Addendum 7: United Nations Global Technical Regulation No. 7

United Nations Global Technical Regulation on Head Restraints

Amendment 1

Established in the Global Registry on 11 November 2020

Figure 1-1
Goniometry in the test procedure using apparatus that facilitate the measurement of coordinates.

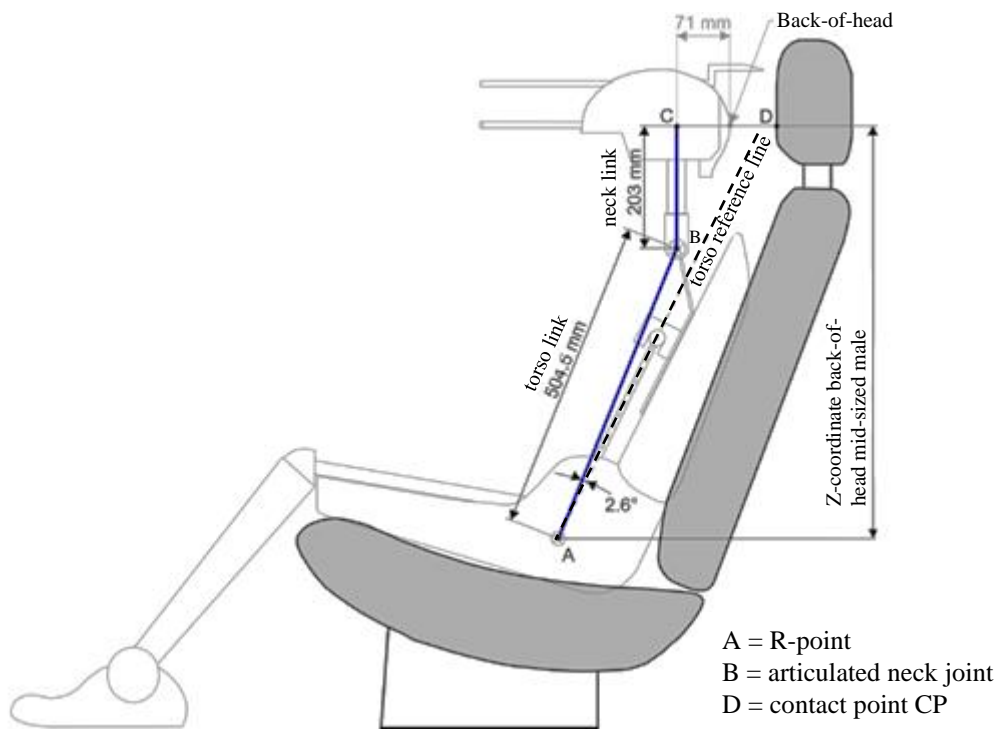
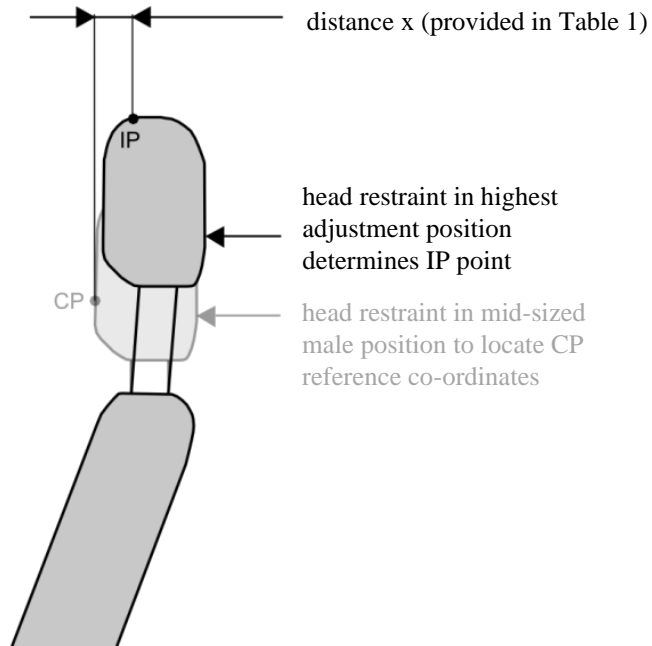
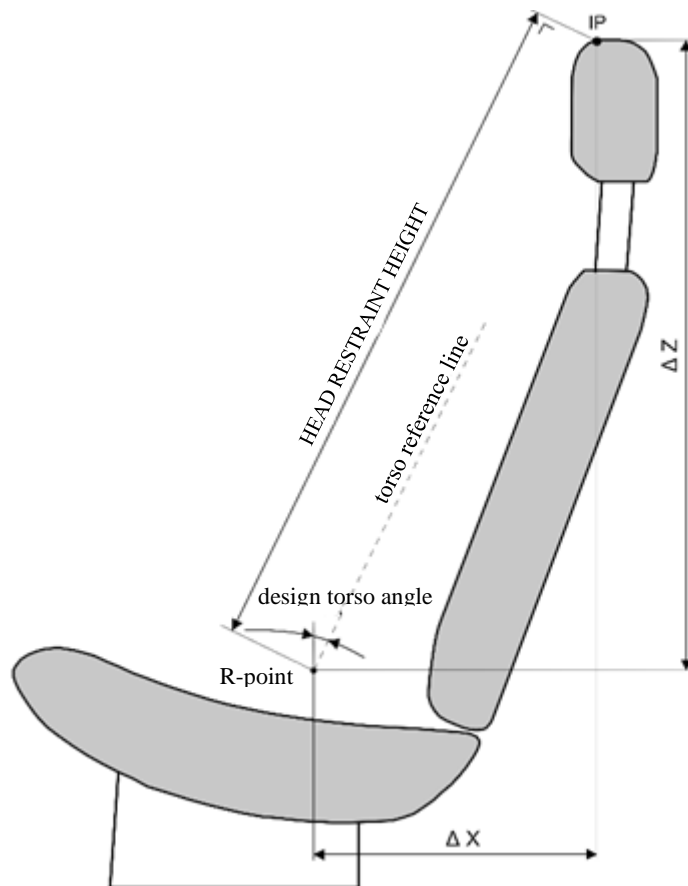
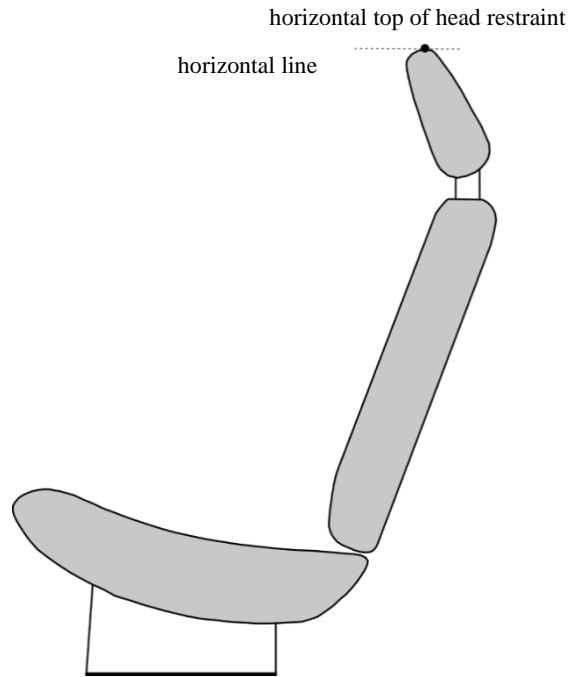
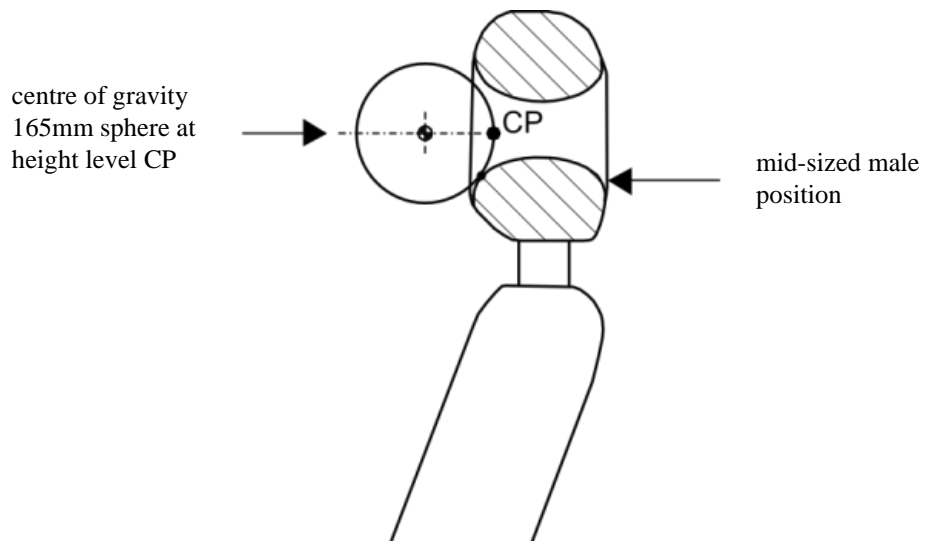
The CP is defined as the intersection of a horizontal line, on the height of the Z-coordinate of the back-of-head of the mid-sized male (as given in table 1), with the front surface of the head restraint as indicated in Figure 1-1.

In the instance where this will not produce a point of intersection, the CP will be designated at the horizontal top of the head restraint. The horizontal top of the head restraint being defined as the uppermost point on the head restraint, which is determined by lowering a horizontal line in the median longitudinal plane of the designated seating position until it touches the head restraint (see Figure 1-4). Where more points are located at the same height, the longitudinally forward most point of the horizontal top of the head restraint is designated as CP.

Where CP cannot be determined because the horizontal line through the back-of-head of the mid-sized male is on the level of a gap within the head restraint, CP will be determined using a 165 mm diameter sphere with its centre at the same height level as the horizontal line through the back-of-head of a mid-sized male. When the sphere is making first contact with the head restraint, the CP is designated as the rearmost point of the sphere in the gap area (see Figure 1-5).

The IP is determined on the front surface of the head restraint as the intersection with a vertical line rearwards of CP (see Figure 1-2) at the "distance x" (as given in table 1).

Where the IP would be located rearwards of the horizontal top of the head restraint, the IP will be designated at the horizontal top of the head restraint (see Figure 1-4).

The head restraint height is the distance from the R-point, parallel to the torso reference line and limited by a line perpendicular to the torso reference line intersecting IP (see Figure 1-3).

After the coordinates of the IP are determined, the highest head restraint height can be calculated by its longitudinal (ΔX) and vertical (ΔZ) distance from the R-point (see Figure 1-3), as follows:

Figure 3-1
Measurement of a vertical gap "A".

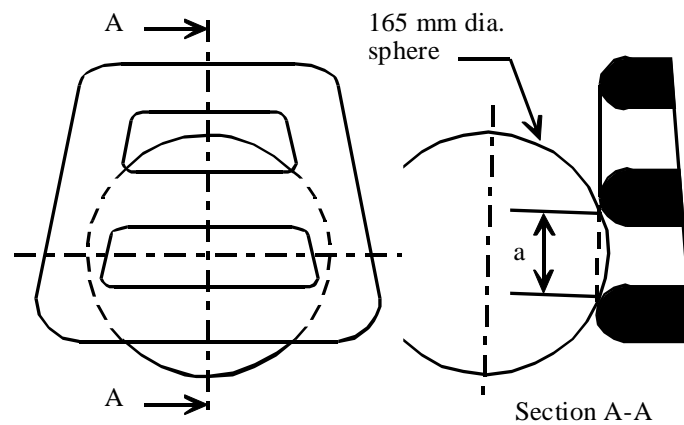
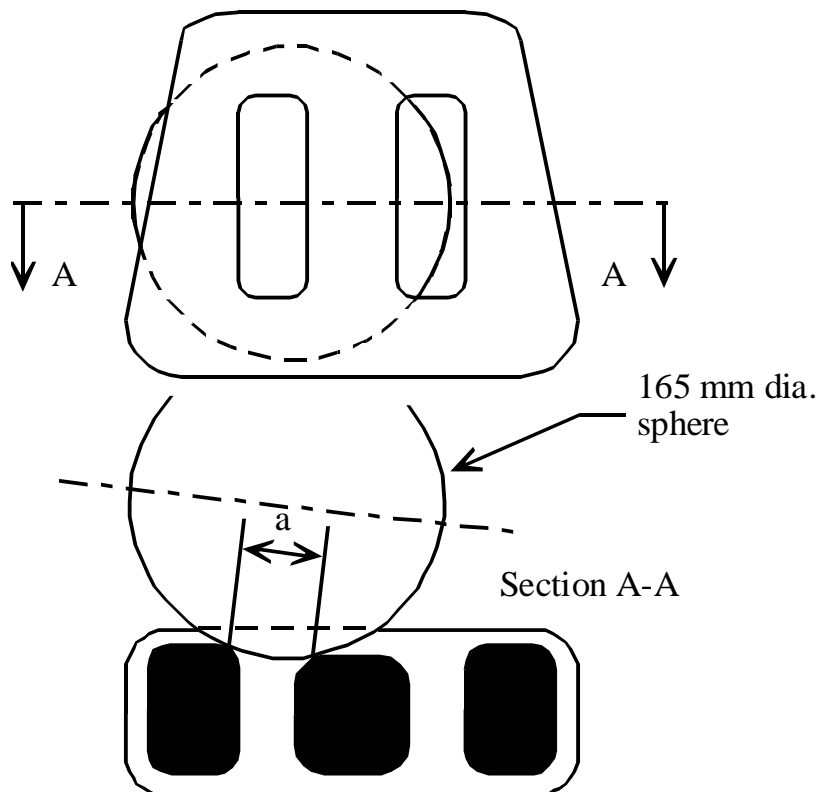
- 2.5. Determine the gap dimension by measuring the straight line distance between the inner edges of the two furthest contact points, as shown in Figures 3-1 and 3-2.

- 2.6. For gaps within the head restraint, if the measurement determined in paragraph 2.5. of this annex exceeds 60 mm, then in order to demonstrate compliance with the requirements of paragraph 5.1.3. of this Regulation, the seat back displacement test procedure described in Annex 5 is performed, by applying to each gap, using a sphere of 165 mm in diameter, a force passing through the centre of gravity of the smallest of the sections of the gap, along transversal planes parallel to the torso line, and reproducing a moment of 373 Nm about the R point.

Figure 8-1

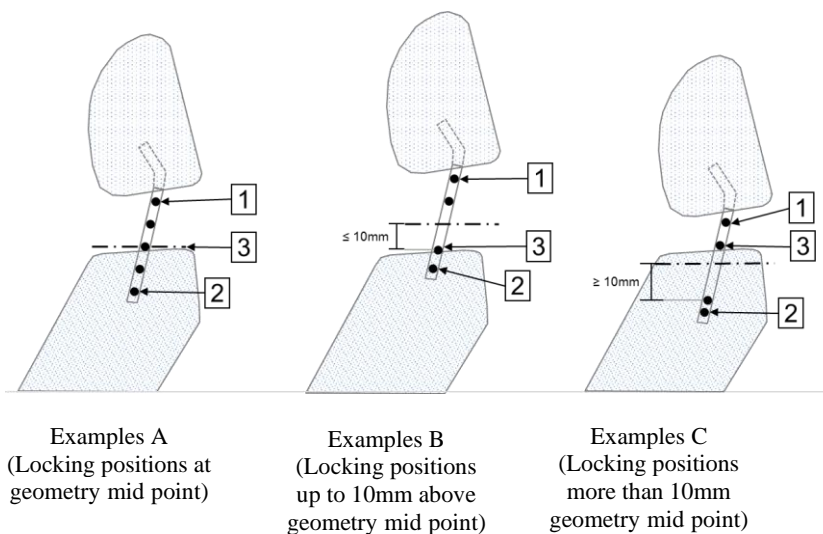
When the head restraint has a locking fore-aft adjustment, it shall be in the midpoint. If a locking position exists within 10 mm horizontally forward from the geometric mid-position, this shall be the test position. If no locking position exists within 10 mm horizontally forwards from the geometric mid-position then the next locking position rearwards shall be the test position, as shown in Figure 8-1.

Figure 8-2

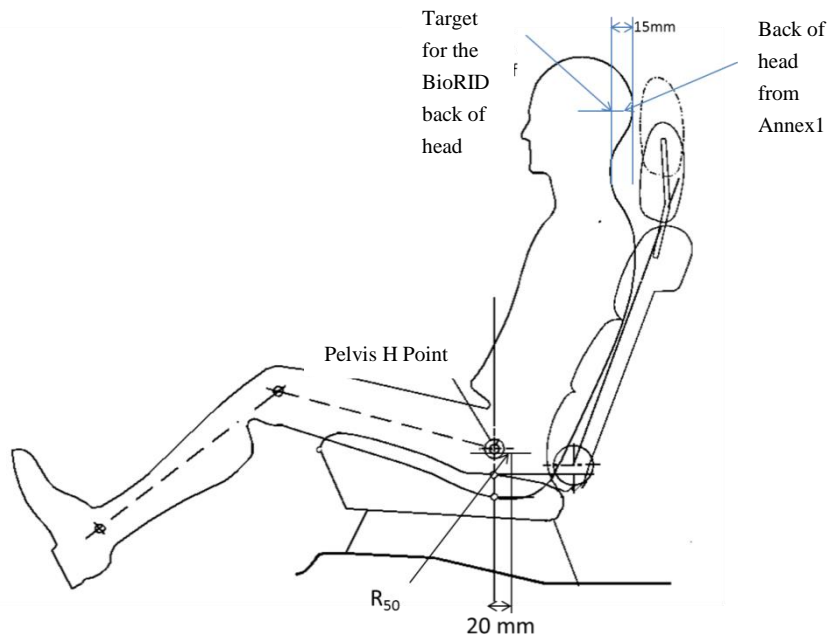
The back of the head reference position for the BioRID II is the value determined for the 50th percentile in Table 1, Annex 1 of this Regulation with reference to the specified torso angle minus 15 mm (increasing the backset as shown in figure 8-2).

3.2.7.6. The BioRID shall be installed such that its H-point is positioned $20 \text{ mm} \pm 10 \text{ mm}$ forward of the R₅₀-point, as shown in Figure 8-1, while keeping the pelvis angle within the range specified in paragraph 3.2.7.5. above.

Figure 8-3
Sled pulse acceleration corridor

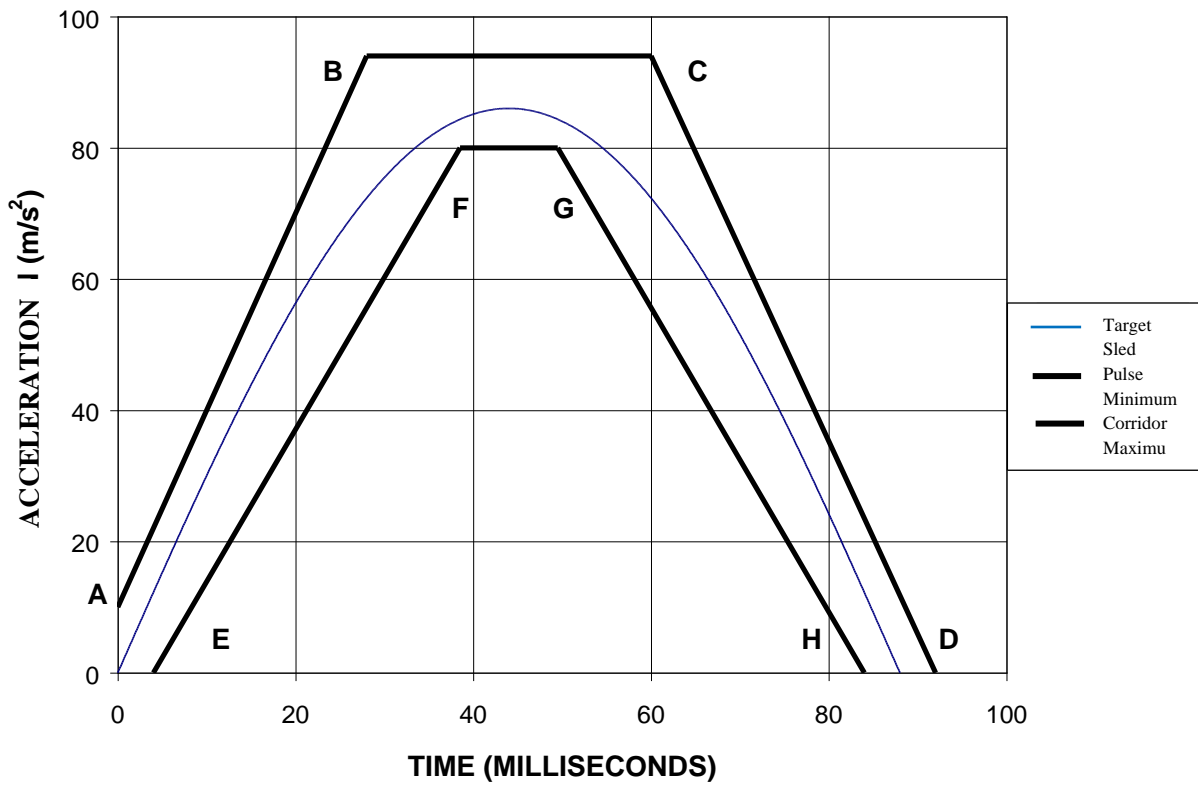
The corridors for the pulse are illustrated in Figure 8-3. The sled acceleration shall be adjusted within the corridors described in Figure 8-3 and Table 8-2 for the complete time interval from 0 to 0.15s. The sled pulse shall fulfil the requirements as specified in Table 8-3.
